13-19 CANBERRA AVENUE, ST LEONARDS

LANDSCAPE AND PUBLIC DOMAIN DA CONCEPT

COUNCIL RFI RESPONSES / AGREED LANDSCAPE CHANGES

Council RFI 4B.i. Basement Setback - ie Canberra Avenue Frontage Agreed Limited Deep Soil Potential

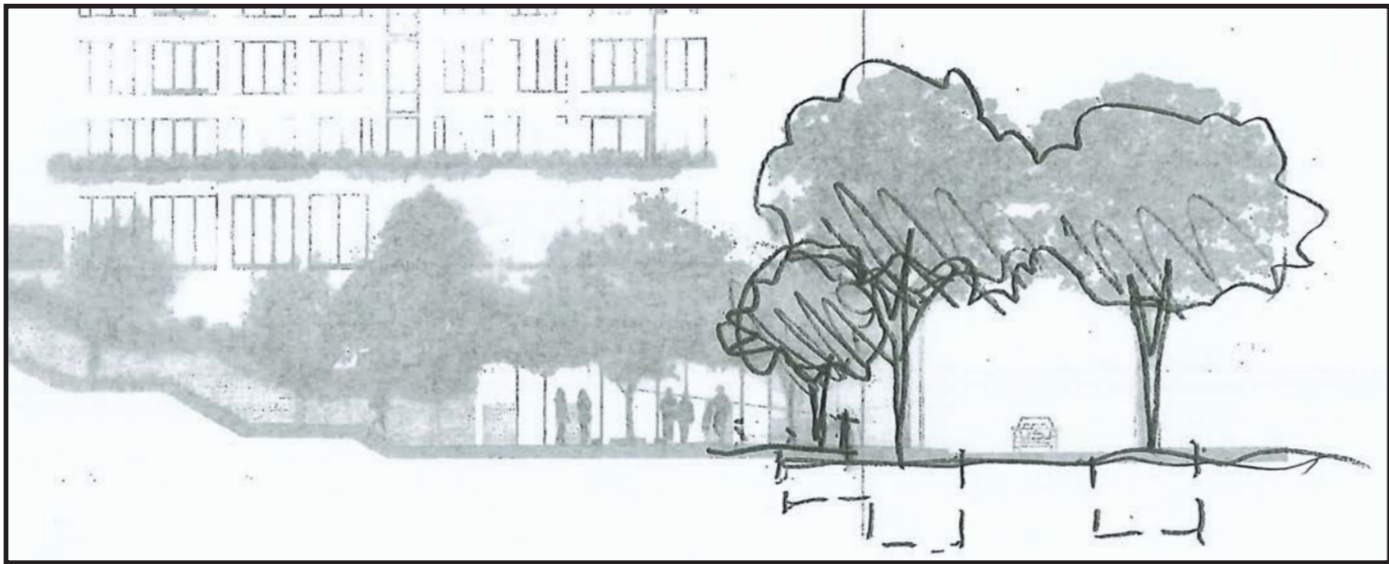
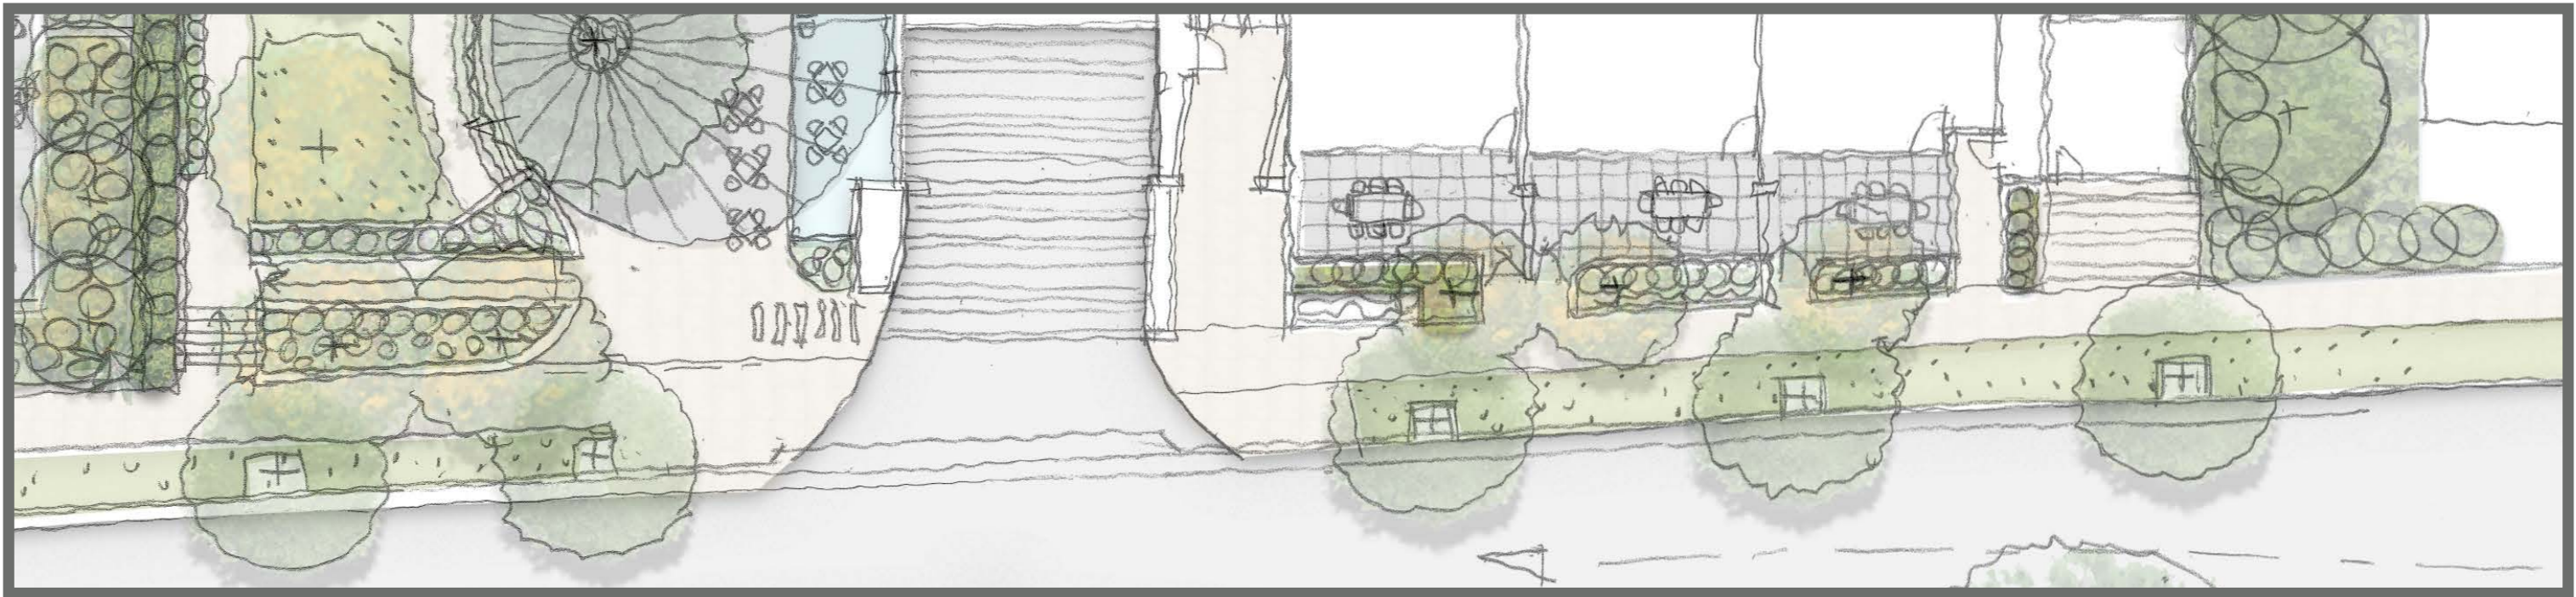
- Council and requested consideration of min. 4m basement setback along Canberra Avenue, as an opportunity to increase Deep Soil on the site. Two factors were discussed:
1. That frontage elements restricted tree planting opportunities, reducing the actual opportunity for trees even if deep soil was provided, including the plaza junction with cafe; driveway; courtyard access paths / gates and paving; substation and access;
 2. That , as per the sketch section presented to Council (below), the scale of adjacent street trees, and the scale of the courtyards and facade rising above, that large trees would reasonably not be planted. Smaller trees in proportion to the courtyards were agreed as suitable.

Response: For the above reasons, Council agreed that Deep Soil (in it's minimum required dimensions) was not suitable for the Canberra Avenue frontage.

Council RFI 6. Landscape Masterplan (including ‘Northern Setback’ response)

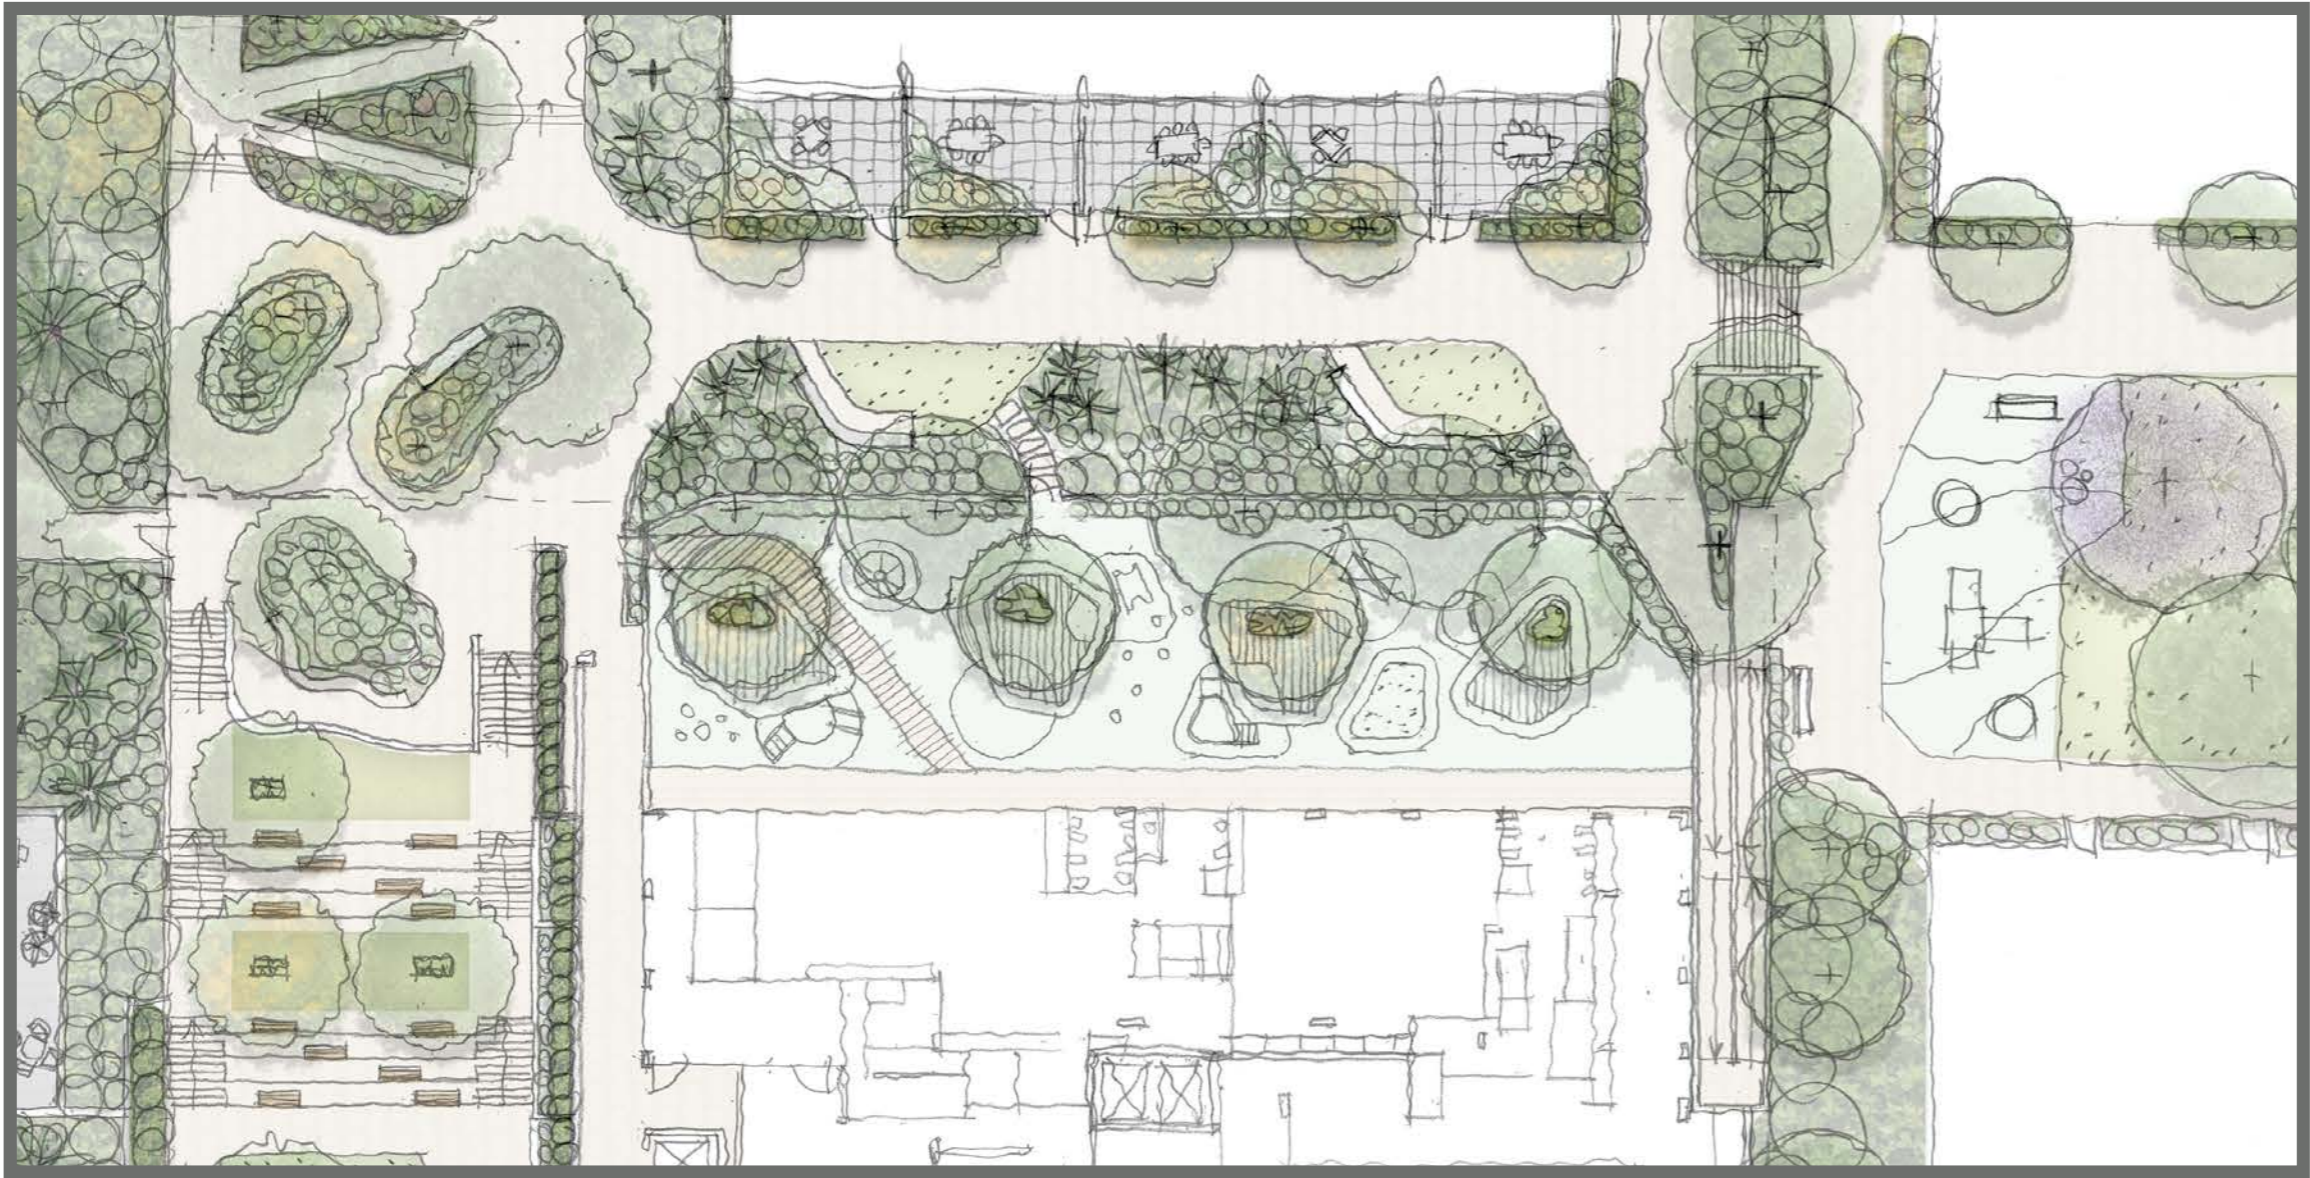
The proposal has been assessed for consistency with the LMP by Council staff and Oculus and the following is requested:

- Pedestrian Link – Compliance with the key LMP transition levels provided in the pedestrian link. Response: Levels now resolved to Masterplan levels as required.
- Northern Setback – The provision of a zero basement setback to the north results in the non-provision of landscaping between buildings which detracts from the LMP intent. Response: As requested, the ‘switchback ramps’ to the boundary to achieve level change on the N/S link is as requested entirely on this site, and precludes planting as agreed.
- Accessible Connection – Provision of an accessible connection to Area 3; Response: As requested, the refined layouts now provide access to Area 3 to Council’s satisfaction.
- Other matters as described in the Oculus assessment provided as Attachment A Response: Refer to RFI Item 10 responses following.

D. Child Care Centre Playground Area

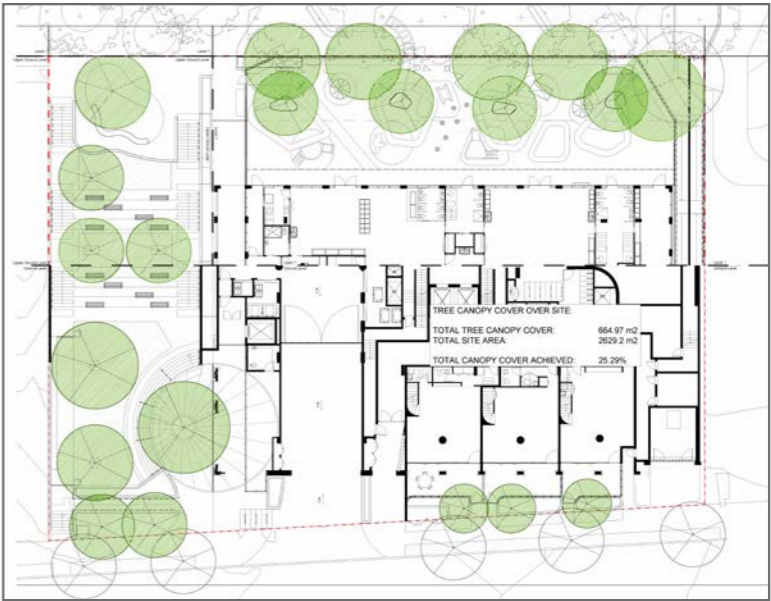
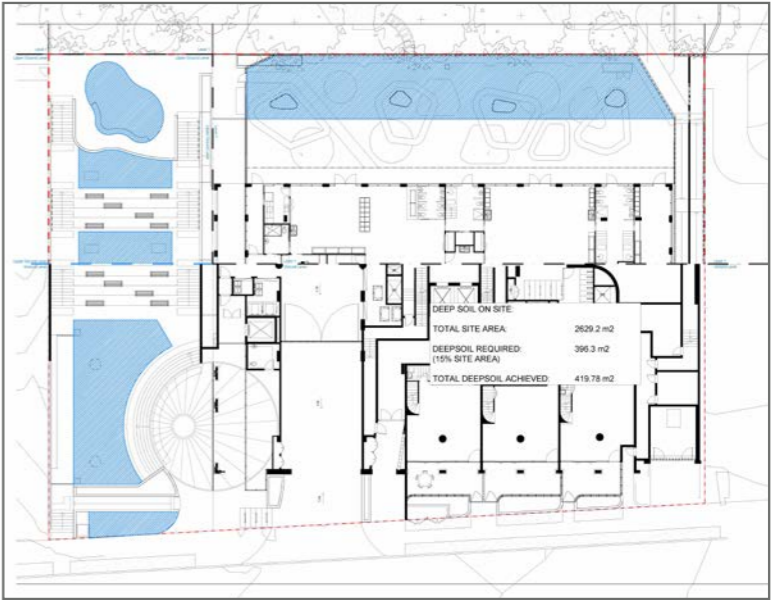
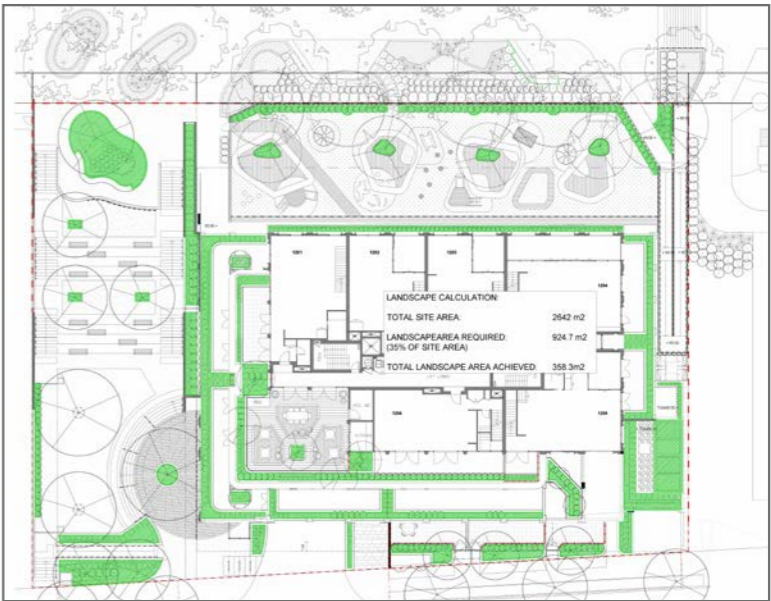
The project Landscape Architect will need to provide more information on the Childcare Centre Playground as well as detailed level information, with proposed 'Musical Play Equipment' removed / replaced. The Landscape Architect must demonstrate compliance with the required outdoor play space as required by the Landscape Master Plan and DCP:

Response: Refer to to accompanying updated Landscape DA drawings. Note that the Council required ramps to the North-South link (NW boundary) reduce the external / play areas and this is understood to be as instructed / agreed. DCP requirement of 462 m2 is achieved, but not more.
